**Addendum No. 1**

RE: Contract # C203987

**Durham County (B-4943)**

Bridge #20 Over Dial Creek On SR-1616

PROJECT NO. B-4943  
 DURHAM COUNTY  
 STATION: 14+67.00 -L-  
 SHEET 1 OF 3    REPLACES BRIDGE NO. 20

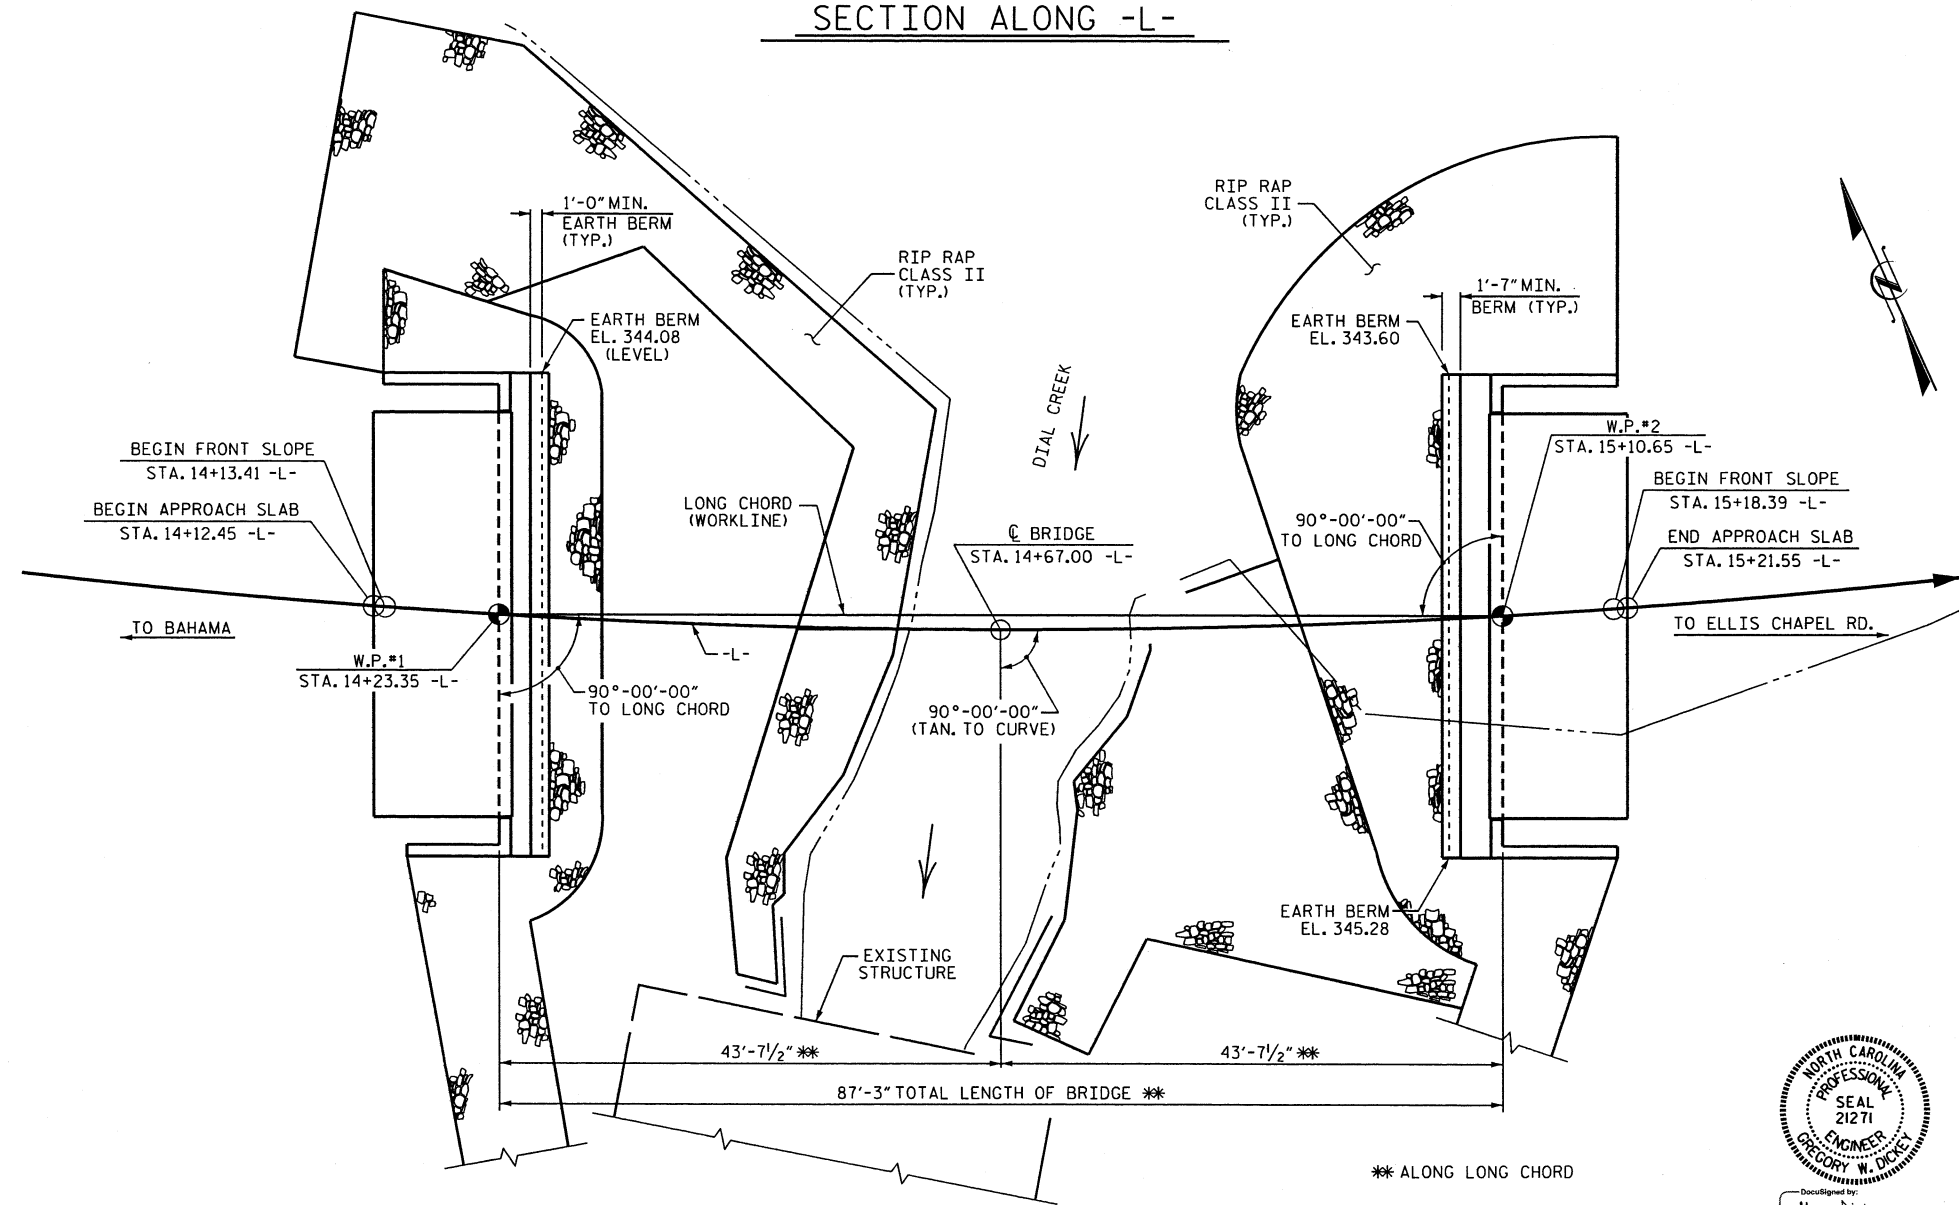
Sheet No.	Revisions
S-1	Revised to remove the Temporary Shoring
S-3	Revised to remove the note concerning Temporary Shoring
